Access Compliance Report

Public Rights-of-Way

(Curb Ramps)

Intersection ID: 45885	Main Street: ETHEL_CT	Cross Street: BEN_LIVINGSTON_RD	Location: S
ADA ID: 6BF063CB2814	Ramp Type: Perp	Initial Pass/Fail: Fail	Overall Compliance: No
		Severity Score: 37.5

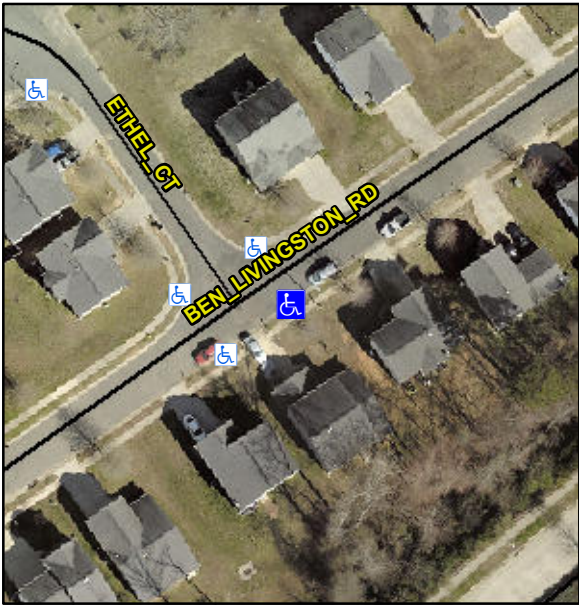
Codes/Mitigation Info/Possible Solution			Field Measurements/Component Compliance					
 <div>Street 1 Name<div>BEN LIVINGSTON RD</div></div> <div>Stop Condition-Street 2<div>None</div></div> <div>Street 2 Name<div>N/A</div></div> <div>Stop Condition-Street 1<div>N/A</div></div>	Possible Solutions:		Compliance	Description	Data	Compliance	Description	Data
	Remove & Replace Entire Ramp.		N/A	Ramp Length (in)	48.0	No	Ramp Slope (%)	14.0
			Yes	Ramp Width (in)	48.0	No	Ramp XSlope (%)	5.4
			N/A	Flare Type LT	N/A	N/A	Flare Type RT	N/A
			N/A	Flare Slope LT (%)	N/A	N/A	Flare Slope RT (%)	N/A
			N/A	Flare Traversable LT?	N/A	N/A	Flare Traversable RT?	N/A
			N/A	Landing Length (in)	N/A	N/A	DWS Provided?	N/A
			N/A	Landing Width (in)	N/A	N/A	DWS Contrast?	N/A
			N/A	Landing Slope (%)	N/A	N/A	DWS Length (in)	N/A
			N/A	Landing X Slope (%)	N/A	N/A	DWS Full Width?	N/A
Surveyor Notes:		N/A	N/A	Landing Curb? (Y/N)	N/A	N/A	DWS Offset (in)	N/A

PROW/ADA:			N/A	Shared Landing?	N/A			
R304.2.2, R304.5.3			N/A	Gutter Ponding?	N/A	N/A	Gutter Slope (%)	N/A
			N/A	Gutter Lip Ht (in)	N/A	N/A	Gutter X Slope (%)	N/A
			N/A	Painted X Walk1?	No	N/A	Painted X Walk2?	N/A
				X Walk 1 Direction	To N		X Walk 2 Direction	N/A
			N/A	X Walk 1 Width (in)	N/A	N/A	X Walk 2 Width (in)	N/A
				X Walk 1 Slope (%)	3.4		X Walk 2 Slope (%)	N/A
				X Walk 1 X Slope (%)	6.2		X Walk 2 X Slope (%)	N/A
			N/A	Ramp inside XWalk1?	N/A	N/A	Ramp inside XWalk2?	N/A
				Road Slope (%)	N/A	N/A	Clear Space?	N/A
				Road X Slope (%)	N/A	N/A	Clear Space to XWalk (in)	N/A
			N/A	Any Obstructions?	N/A	N/A	Storm Grate/Utility Hazard?	N/A
				Obstruction Type			Storm Grate/Utility Type	
					N/A			N/A
						Yes	Surface Condition? (G/P)	Good
Total Cost:		\$	1850.00
